## ADDENDUM NO. 1

PROJECT: Dry Fork Belt Creek Fish Barrier Project

FWP PROJECT #: 14-47

DATE: 07/17/14

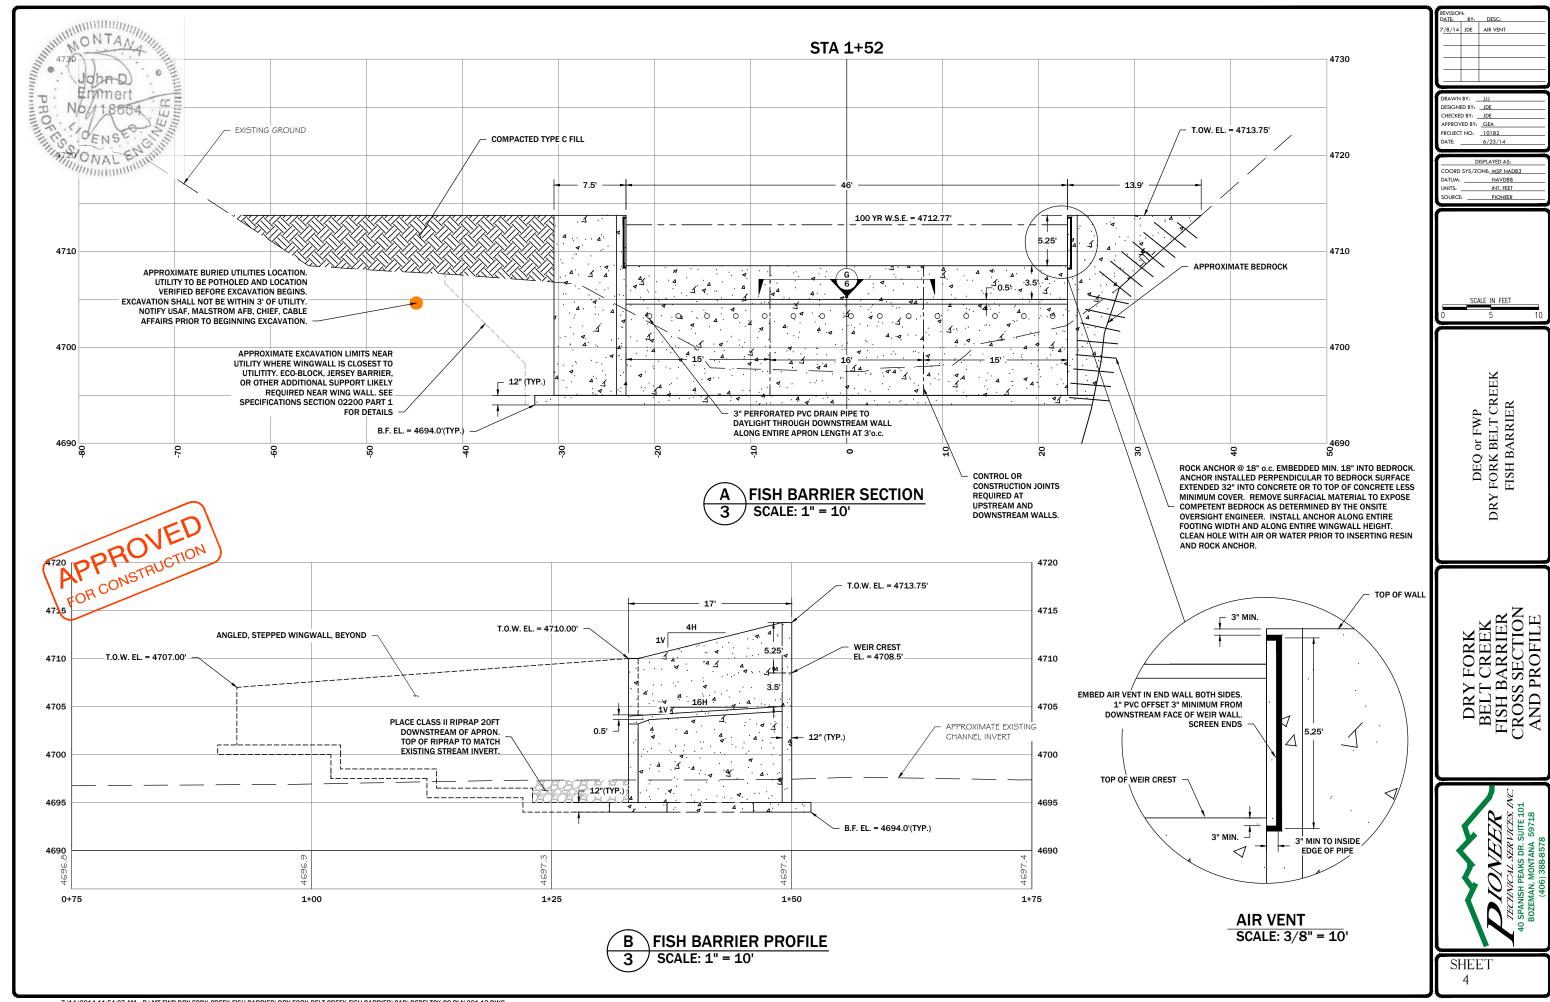
- 1. **REPLACE** Sheet 4, with attached Sheet. (1 page)
  - Sheet 4 has been revised to include an air vent in the wing wall near the weir crest.
- 2. An ENGINEER'S ESTIMATE for fill quantities for Class II Riprap, Type B Fill, and Type C Fill is included with this addendum as Table 1. These quantities are for informational purposes only. It is the responsibility of the contractor to verify these quantities as necessary for bidding purposes. Some of these fill materials may be able to be found from onsite excavation but the contractor is responsible to verify that any onsite materials that are used meet the specifications of the contract. The engineer accepts no responsibility for these quantities as they pertain to the bid.
